Docket Item # 10
DEVELOPMENT SPECIAL USE PERMIT #2003-0007
MEUSHAW DEVELOPMENT

Planning Commission Meeting
February 3, 2004

ISSUE: Consideration of a request for a development special use permit for outlot subdivision with site plan for construction of new single family residences

LOCATION: 206 N. Quaker Lane

A. Tree Preservation:

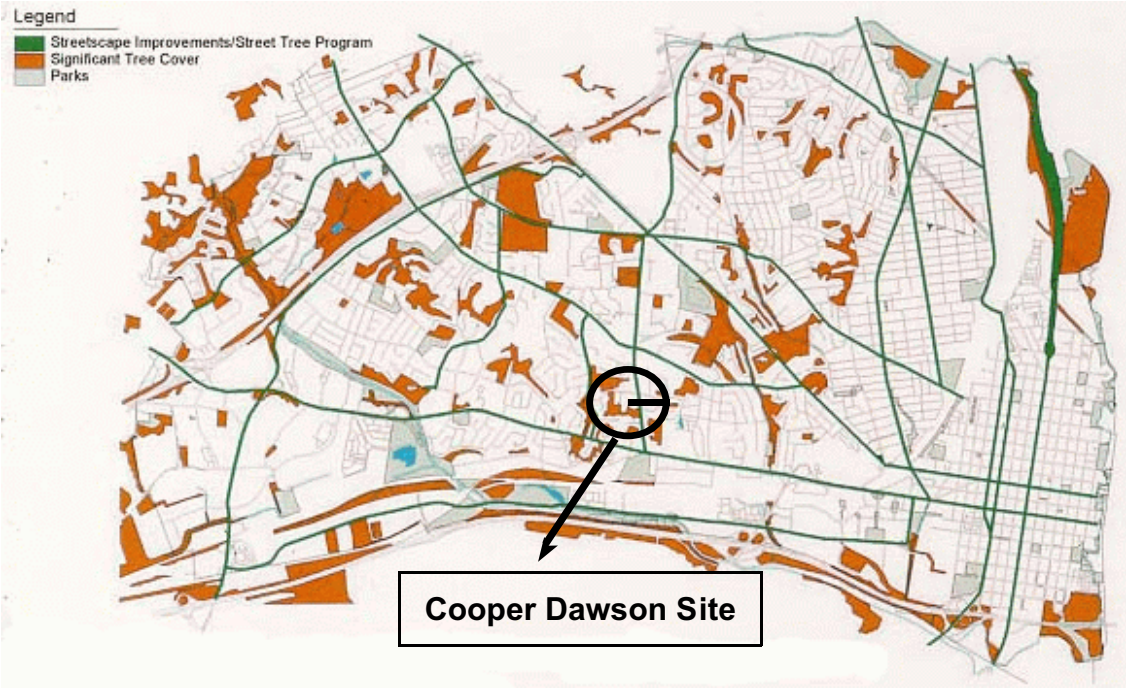
The proposal is consistent with the intent of the Open Space Plan “to protect existing trees and woodland areas.” The site is identified in the Open Space Plan as an area of significant tree cover as depicted below.

Trees in Proposed Rear Yard Areas

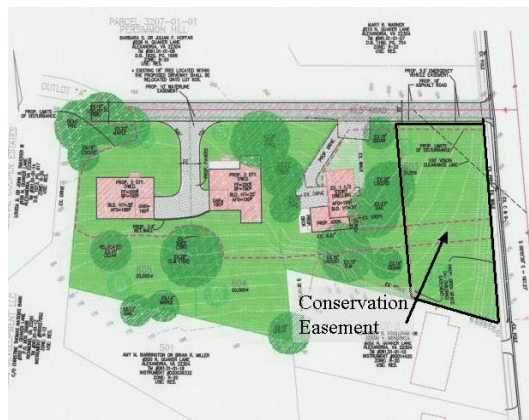
The applicant has worked with staff to retain 14 of the 18 existing trees on the site. A recommendation of approval is that these trees will need to be retained. A significant penalty (\$10,000) will be imposed if any of the trees are impacted during the construction process and a significant amount of replanting will also be required. The applicant has worked extensively with staff to locate the homes, streets and utilities in a way that enables the retention of the trees and tree canopy for this site. In addition, the applicant and the City explored numerous alternatives to retain the 18" cedar located on the western portion of the site. Due to utilities, and emergency vehicle access, the tree could not be retained at its current location (within the area of the proposed driveway). However, the applicant agreed to relocate the tree on the site.

The applicant has worked with staff to resolve the issue of locating the proposed homes in a manner that provides for protection and preservation of as many existing trees as possible. Staff's support for two single-family residences was predicated on resolving the issues of locating two single-family homes on the site without significant loss or impacts to existing trees. The current proposed plan retains most of the existing trees with only one large tree designated for removal and another as described above to be relocated.

- b. Additional evergreen planting/screening on the southern portion of lot 604 and lot 605.
 - c. The 18" cedar tree on lot 605 shall be relocated to the southern portion of lot 605 to the satisfaction of the City Arborist.
 - d. All existing landscaping and trees on the northern portion of the access road shall be retained.
 - e. All landscaping shall be maintained in good condition and replaced as needed.
 - f. All plant materials and specifications shall be in accordance with the current and most up to date edition of the American Standard For Nursery Stock (ANSI Z60.1) as produced by the American Association for Nurserymen; Washington, D.C. (P&Z)
6. Decorative porous pavers shall be installed for the length of the two proposed driveways to the satisfaction of the Director of Planning & Zoning. (P&Z)
